VIRGINIA ELECTRIC AND POWER COMPANY (DOMINION)
SUBMITTAL OF APPROVED TOPICAL REPORT VEP-FRD-42, REVISION 2.0-A
RELOAD NUCLEAR DESIGN METHODOLOGY FOR APPLICATION AT
NORTH ANNA AND SURRY POWER STATIONS

VEP-FRD-42 Rev. 2.0-A
August 2003

**Reload Nuclear Design
Methodology**

RAI Questions and Responses Set # 1

N1C16 Flux Map 3 (100% Power ARO) FQ
Measured versus PDQ

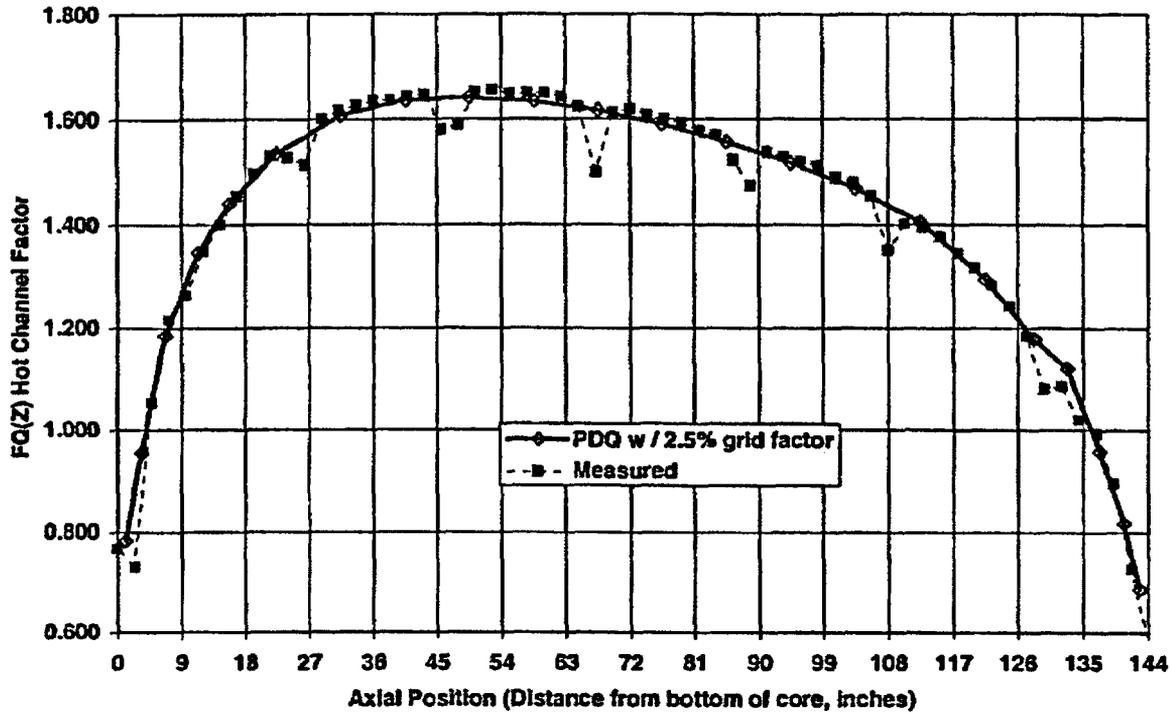
NRC PDO QUESTION 2

**N1C16 Flux Map 3 (100% Power ARO) F(Z)
Measured versus NOMAD (Excluding 2.5% Grid Factor)**

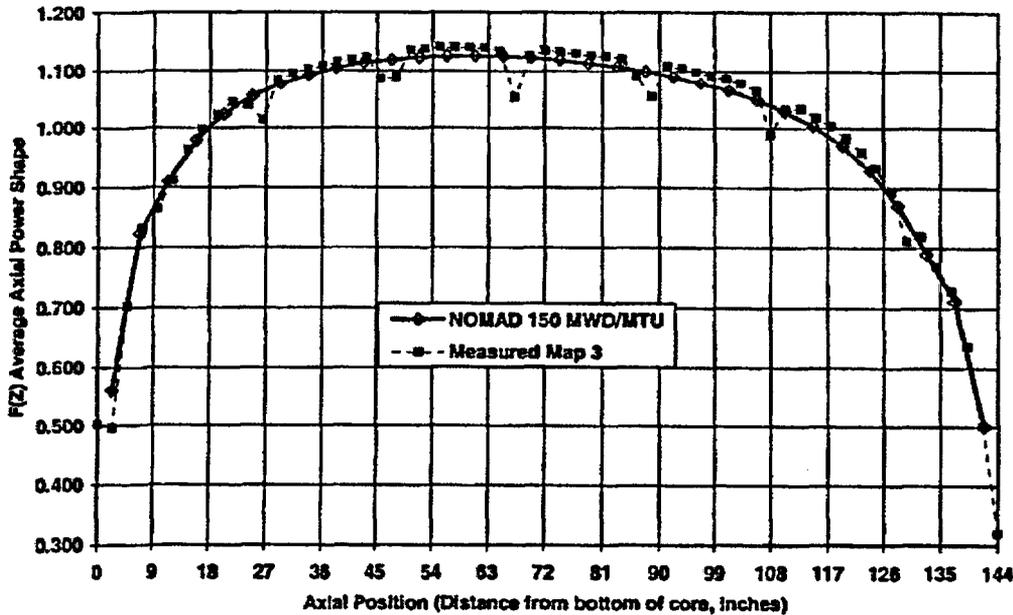
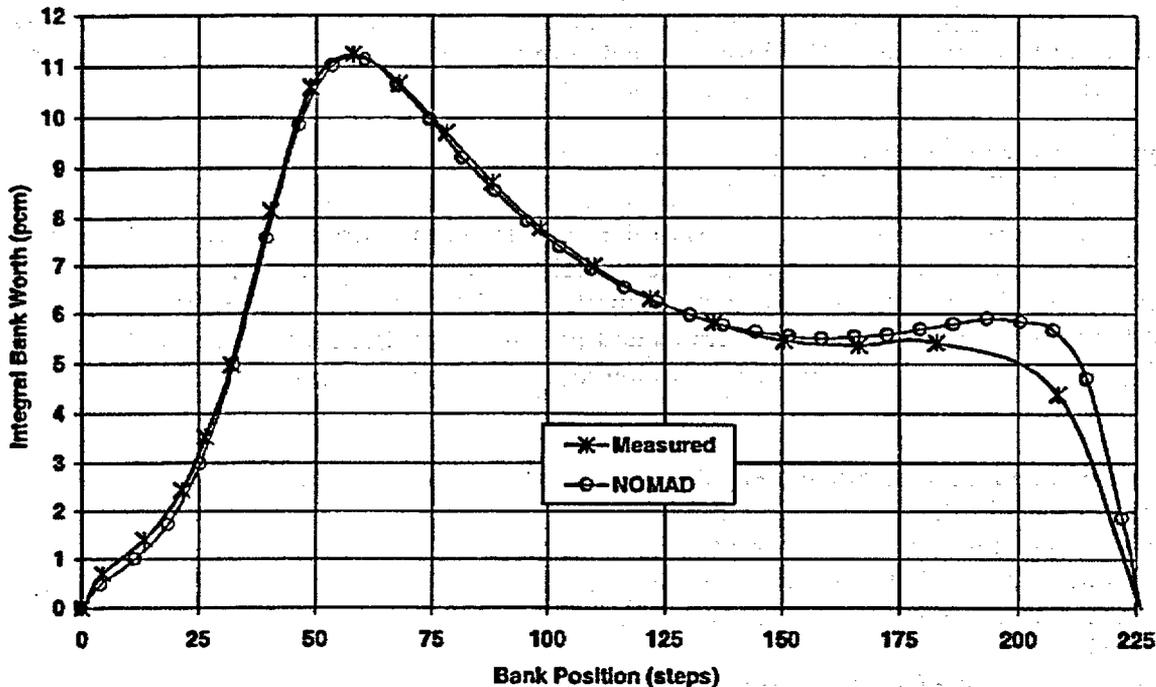
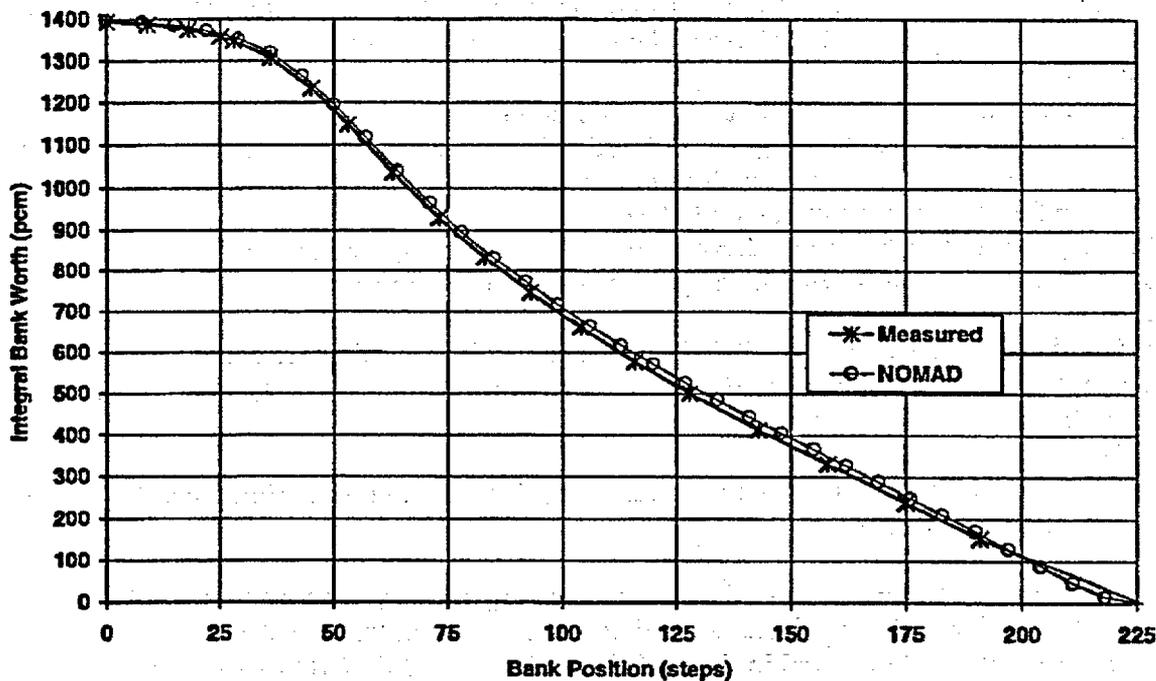
NRC NOMAD QUESTION 2

There do not appear to be any limitations or restrictions associated with the use of NOMAD as described in this submittal. Please justify that NOMAD is applicable over all ranges of operation expected for North Anna and Surry.
